**AMENDMENT TO DESIGN AND CONSTRUCTION STANDARDS
NO. 17-01**

Authority by Chapter 23 – Subdivision, Sec.23-15 of the Code of Ordinances

914. Construction Standards and Specifications

Local Street
(Residential / Commercial / Industrial)
Figure 9-4

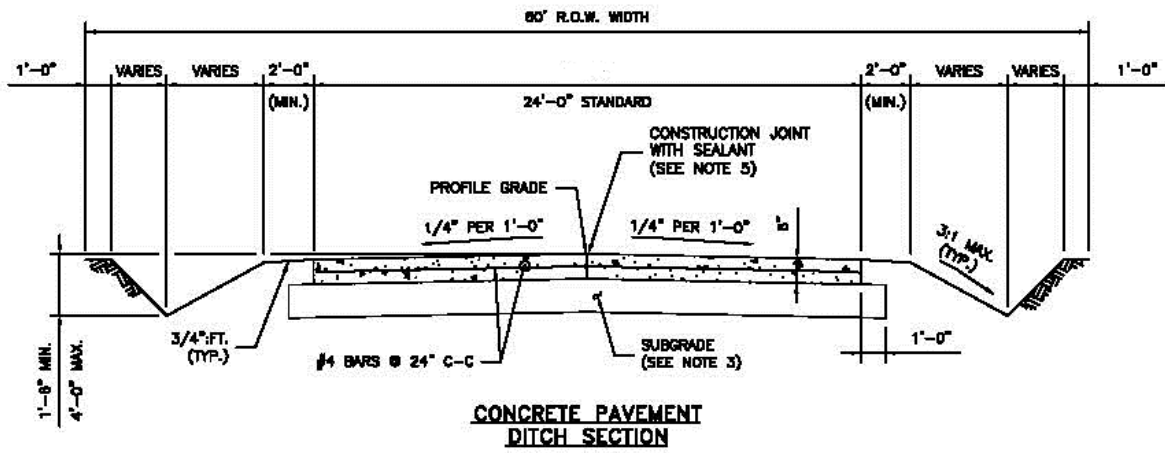
All local residential streets shall be constructed with concrete curb and gutter with concrete pavement sections.

The following figures is in addition to Figure 9-3, Minor Collector Street, Figure 9-4 Local Street (Commercial/Industrial), and replaces Figure 9-4, Local Street (Residential) and Figure 9-5 Local Street (Residential) Low Density Rural

**CONCRETE PAVEMENT
CURB & GUTTER SECTION**
(PARABOLIC CROWN IS AN ACCEPTABLE OPTION)

Figure 9-6

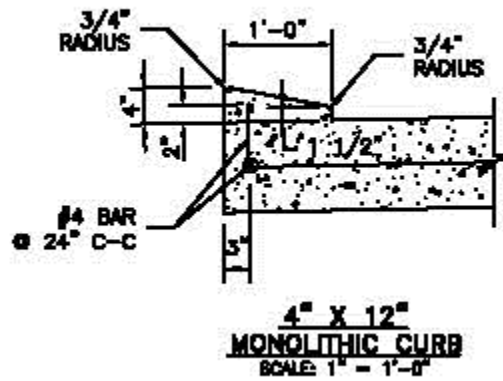
An alternate local street residential road section may also be used to include laydown curbs with the City Engineer's approval.
